AMENDMENT TO THE DRAWINGS

## REMARKS

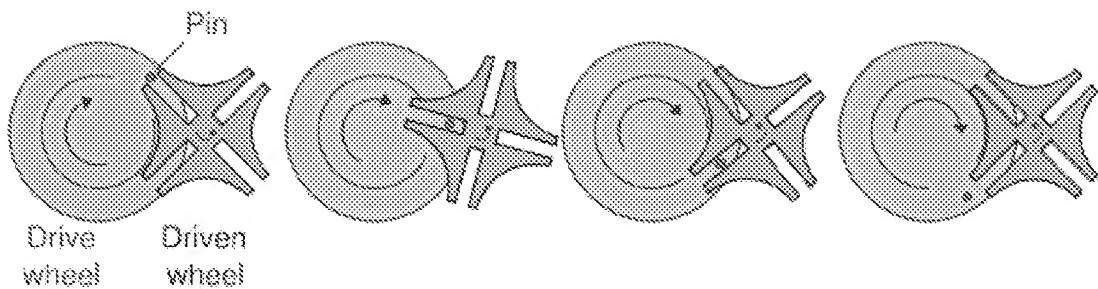
The specification has been objected to for numerous reasons. A substitute specification is being submitted herewith. No new matter has been added. For the most part the amendments to the specification merely involve rearranging the original text. Other than that, some brief description of features which were clearly disclosed in the original drawings as filed has been added. For example, in Fig. 1, a cutting blade has been added with a new reference numeral 16. The blade was described in the original specification as filed. In Fig. 2, the torsion fingers have been labeled as described above. The original specification referred to a cutting groove 11. However, it is clear from Fig. 2 that numeral 11 is referring to an angled wall which has a partner (now numbered 11a

and 11b) and an overlying wall (now numbered 11c) with the cutting groove (now numbered 15) cutting through the overlying wall 11c and extending between the angled walls 11a, 11b. The specification has been amended to conform the description to the drawing. The cutting groove 15 clearly lies between these angled centering walls 11a, 11b. Lastly, the indexing wheel 8 has been described as what it clearly is, i.e. a plate driven by a Geneva wheel drive mechanism. In particular, those skilled in the art, looking at Fig. 2 will recognize that the plate 8 is driven by Geneva wheel 14a which in turn is driven by a driver 14b using pin 14c. Below is an illustration from Wikipedia of a Geneva drive.

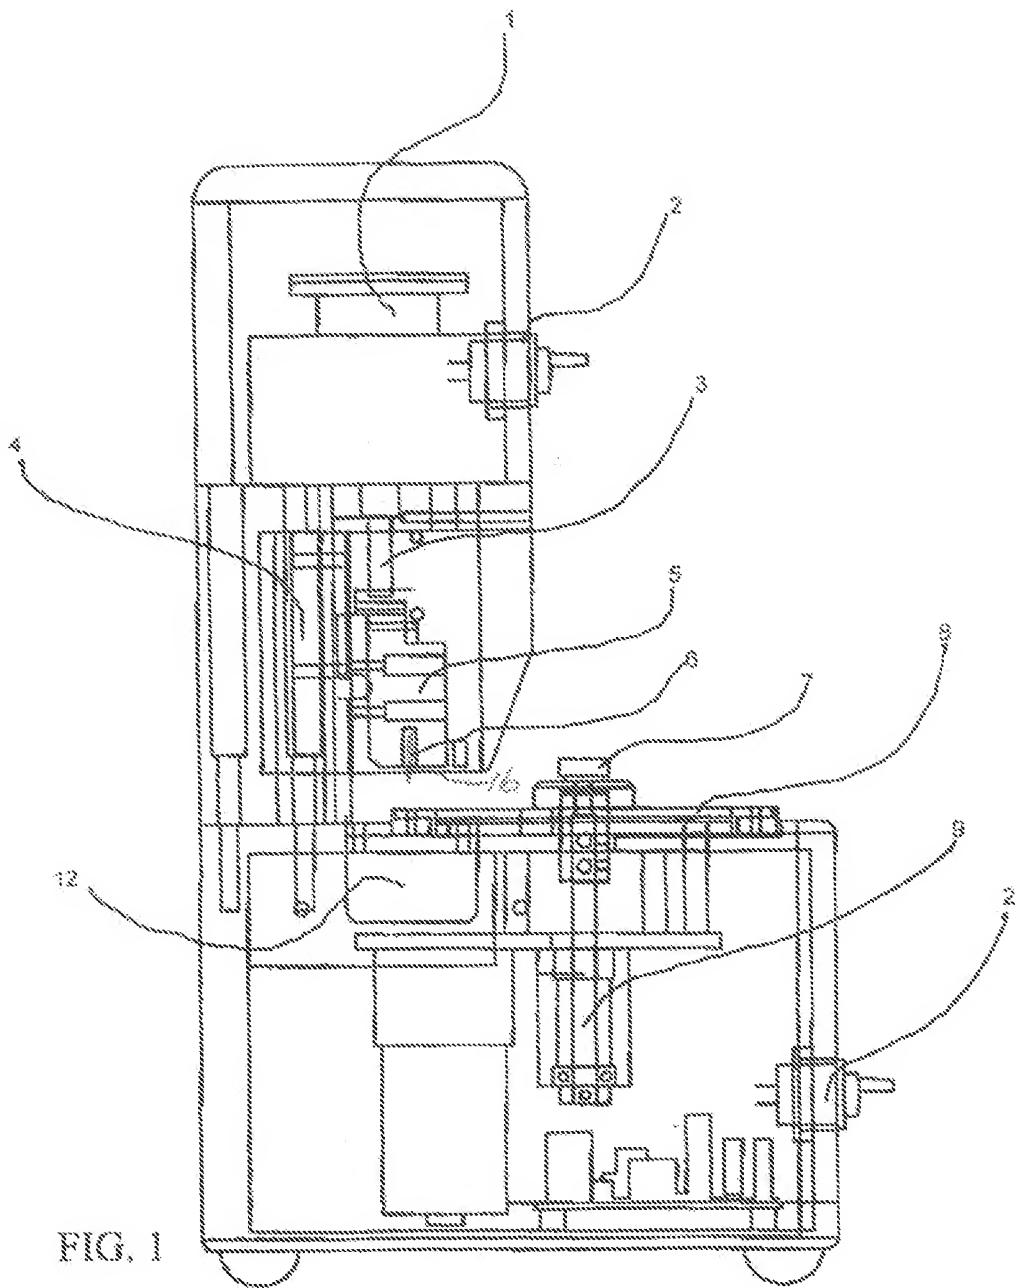
Turning now to the Examiner's specific objections point by point, the Examiner states that it is not clear "how the end cutting edges of the two axially cutting knives are directed toward one another." Since those words do not appear in the application, the Applicant cannot respond to this objection. The Specification as originally filed referred to a single blade, now identified in Fig. 1 as numeral 16 which moves up and down with the pills on the indexing wheel below it.

The attached two sheets of drawings include changes to Figs. 1 and 2 and replace original Figs. 1 and 2. In Fig. 1, a cutting blade 16 is now shown and the lead line for the solenoid 1 has been lengthened to touch the solenoid. In Fig. 2, additional reference numerals have been added.

FIG. 2

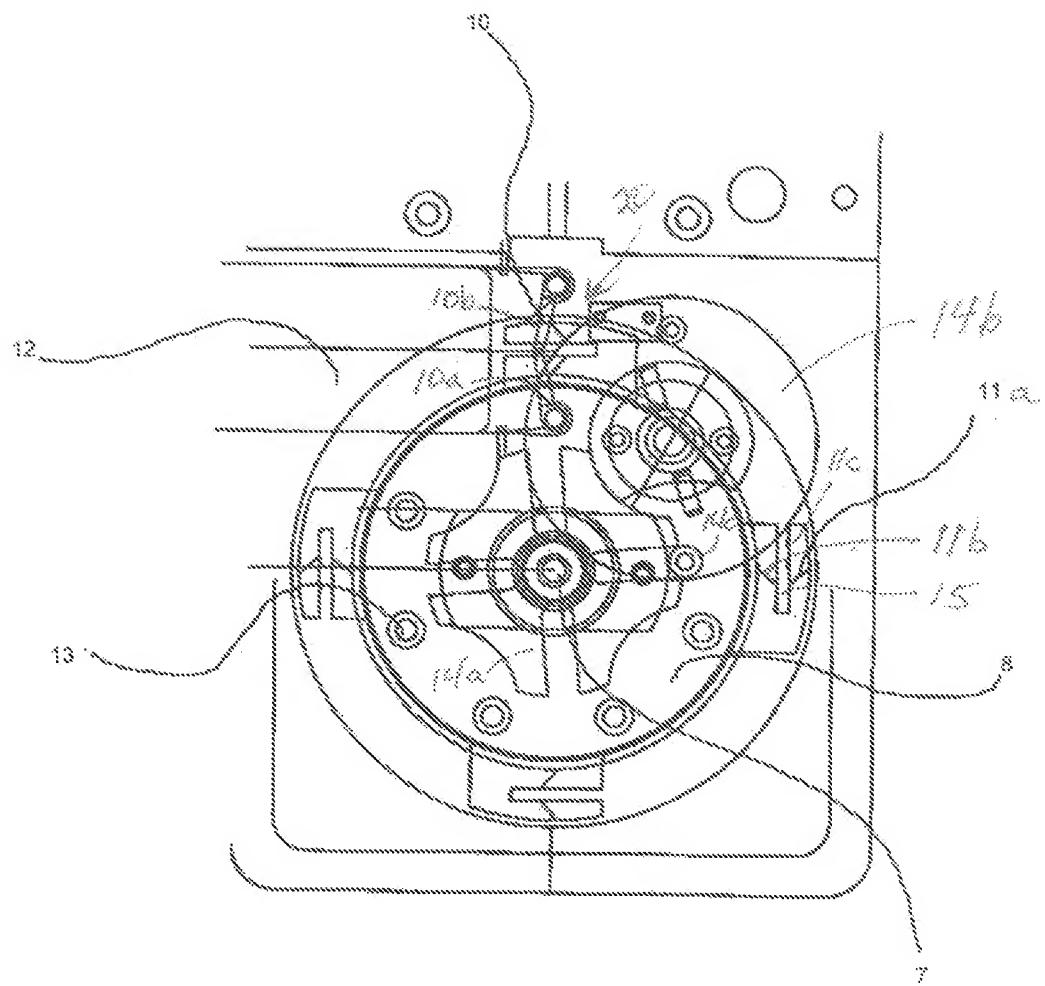
The drawings are objected to for not showing right and left torsion fingers. These fingers were shown in Fig. 2 of the application as filed and were referred to generally as reference numeral 10. Additional reference numerals 10a and 10b have been added to Fig. 2 to clarify where the fingers are and a brief description has been added to the specification. No new matter has been added.

The Examiner next asks "how the self centering pharmaceutical [pill cutter] functions and cut different pill sizes." It is believed that the correction of the description of Fig. 2 to describe what is clearly shown explains how the pill centering works. There

The Examiner then again asks “how the torsion fingers keep the pill at center before cutting” and how they work. It is believed that original Fig. 2 and the original

Further regarding the torsion fingers, the Examiner asks how they spring back. It is believed that original Fig. 2 and the term torsion finger suggests that a spring is at work. Further, an understanding of the Geneva drive clearly indicates that the pill is pressed against the torsion fingers and spreads them apart after the pill is cut and the indexing wheel is moved to the next pill.

are angled walls 11a, 11b on opposite sides of the cutting groove 15. The pill resides between walls 11a and 11b and under wall 11c. When the indexing wheel brings the pill into position beneath the blade, the walls 11a, 11b tend to center the pill relative to the groove (slot) 15, and depending upon the size of the pills, the torsion fingers 10a, 10b may also bias the pill towards the walls 11a, 11b to center the pill over the groove beneath the blade. It should also be apparent from Fig. 2 that this arrangement will function properly with any pill which has a diameter greater than the width of the groove 15.

As to how the wheel accommodates different pill sizes without changing the wheel, that has been explained above with regard to the angled walls 11a, 11b. As to different shaped pills, it is clear that the wheel shown in Fig. 2 will accommodate more than one shape pill, though not necessarily all shapes.
